Marine Corps Assault Amphibious Vehicle Survivability Upgrade

SUBJECT: Marine Corps Assault Amphibious Vehicle Survivability Upgrade
(Report No. DODIG-2018-060)

SUBJECT: Marine Corps Assault Amphibious Vehicle Survivability Upgrade
(Project No. D2017-D000AT-0119.000)

Figure 2. Acquisition Milestones for the AAV SU Vehicle

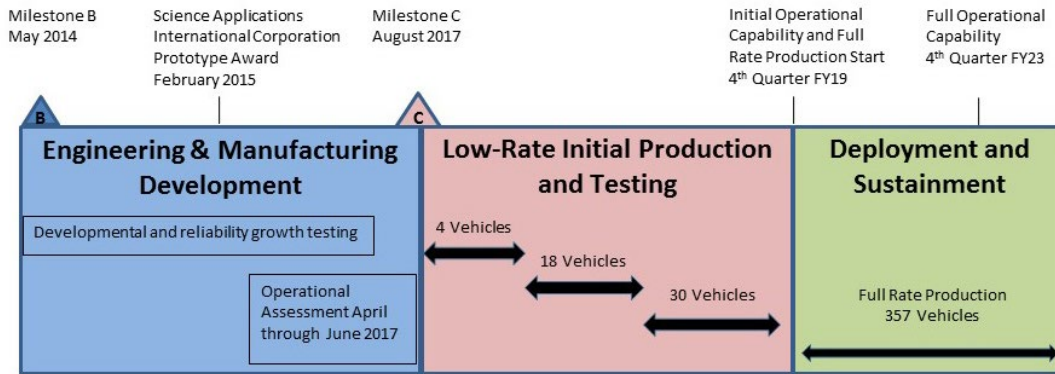
Item: The Acquisition Management paragraph omits mention of the Full Rate Production Decision Review (FRP DR) that follows Milestone C and that the FRP DR is informed by Initial Operational Test and Evaluation (IOT&E) and Full-Up System Level Live Fire Test and Evaluation (LFT&E). This fails to account for the opportunity that the program office has for corrective action and testing between Milestone C and the full rate production decision. The report's conclusion that the AAV-SU did not meet all requirements at Milestone C is true, but it does not explain that the program has time and opportunity to address the reliability, tactical egress, and cracked hull performance problems discovered in testing.

- Change "three milestones" to "four milestones" and add FRP DR as a bullet under Milestone C.
- Change the last sentence on page 3 as follows: The Program Executive Office (PEO) and program office plan to use these vehicles for additional reliability testing which should allow the opportunity for identification and implementation of corrective actions prior to the IOT&E and FRP DR.
- Add IOT&E and FRP DR to Figure 2 at the top of page 4.
